20-TF-0106
REISSUE

REISSUE - THE U.S. DEPARTMENT OF ENERGY, OFFICE OF RIVER PROTECTION,
TRANSMITTAL OF RPP-RPT-61684, MAINTENANCE AND PERFORMANCE
MONITORING PLAN FOR THE INTERIM BARRIERS PROGRAM, REV. 2.

RPP-RPT-61684, MAINTENANCE AND
PERFORMANCE MONITORING PLAN FOR
THE INTERIM BARRIERS PROGRAM, REV 2.

REVIEW COMMENT RECORD	Date 9/18/2020	Review No. 1
	Project No.	Page 1 of 7

Figure 2. T Farm monitoring nest locations (black diamonds)

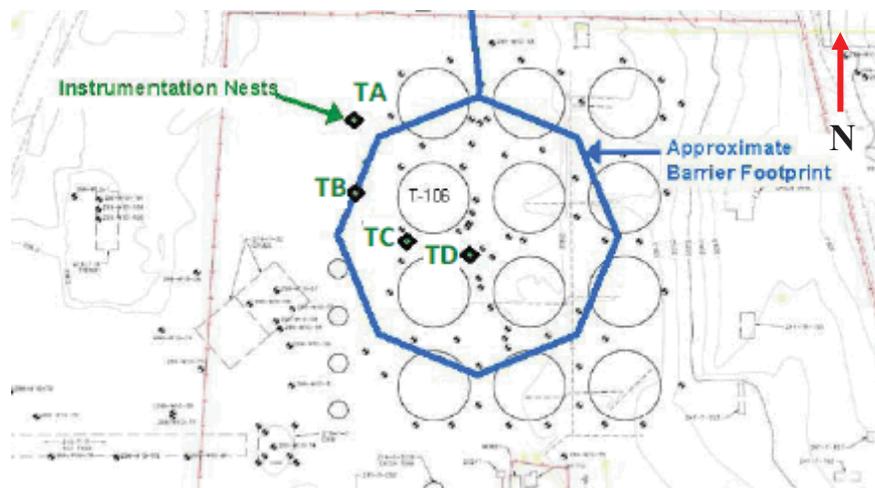
result from the revision of RPP-9937 will be reflected in a future revision of this work plan.		XXXXXXXXXXXXX	XXXXXXXXXXXXX
10	Page 5, lines 1-3.	Are there neutron access tubes in T Farm? Please clarify and discuss how moisture monitoring in deep soils will be performed at T farm.		Accepted	Added information on neutron logging and added to a depth of 50 feet.
11	Page 4, Section 3.2.3	Remove the last sentence. List the in-tank and ex-tank monitoring (e.g., drywell logging) requirements for T Farm identified in RPP-9937. Please add a statement that these in-tank and ex-tank monitoring requirements applicable to T-Farm may be revised when RPP-9937 is revised, and that this revision will be reflected when this work plan is updated and submitted to Ecology with each new interim surface barrier design as required under Ecology et.al. 1989, HFFACO Milestone M-045-92.		Accepted	
12	Page 4, Section 3.3.1	Add a figure illustrating locations of monitoring nests at T Farm.		Accepted

Figure 2 shows the performance monitoring nest locations installed at T Farm. Nest TA was placed in an area outside of the interim surface barrier at T Farm to serve as a control. Control nests needed to be at least 5 m (16 ft) away from the closest edge of the surface cover to prevent measurable impacts from the cover (PNNL-16538). Nest TB is at the edge of the barrier to monitor the edge effect of the barrier on the soil-water regime. TC and TD nest sites are fully located within the barrier footprint. TC and TD locations were determined to be at least 5 m (16 ft) from the closest edge of the interim surface barrier and between two or more tanks where the largest change of soil water content (θ) will be expected with the emplacement of the interim surface barrier.

Figure 4. Location of nest monitoring sites at the TY Farm (blue squares)

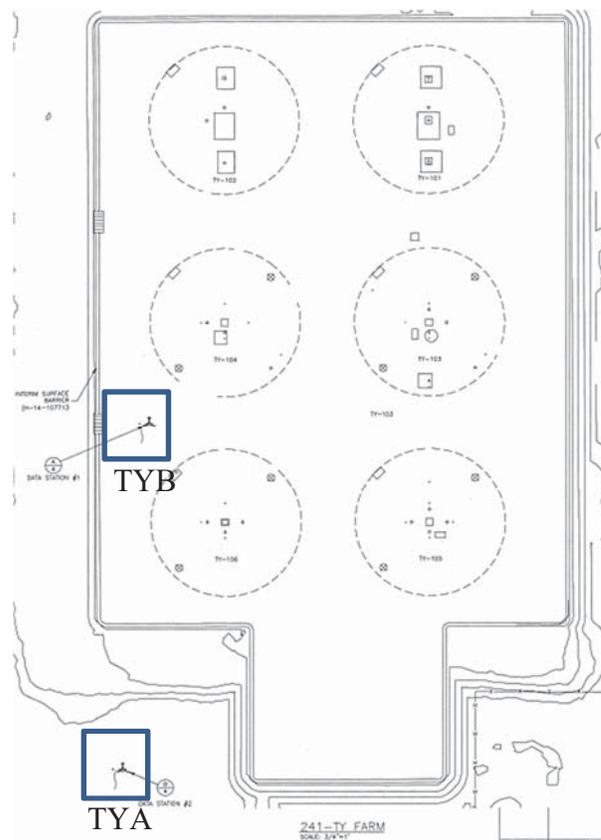
23	Page 9, section 4.2.1, last sentence	The last sentence in the first paragraph is not clear. Was the intent to say that water flux was expected due to large changes in soil water content between the tanks? Please revise.		Accepted	Deleted, "and hence water flux" from the last sentence
24	Page 9, section 4.2.1	Please add a figure illustrating locations of nest sites.		Accepted

TY Tank Farm has two nests (TYA, TYB) that can be seen in Figure 4. Each nest includes a neutron probe access tube, a capacitance probe with five sensors, and four HDUs. Nests TYA and TYB were installed in FY 2010, and monitoring was initiated in March 2010. Monitoring nest instruments collect moisture data that determines whether the soil under the barrier is drying out. These results will be routinely published in the annual interim surface barrier monitoring report.
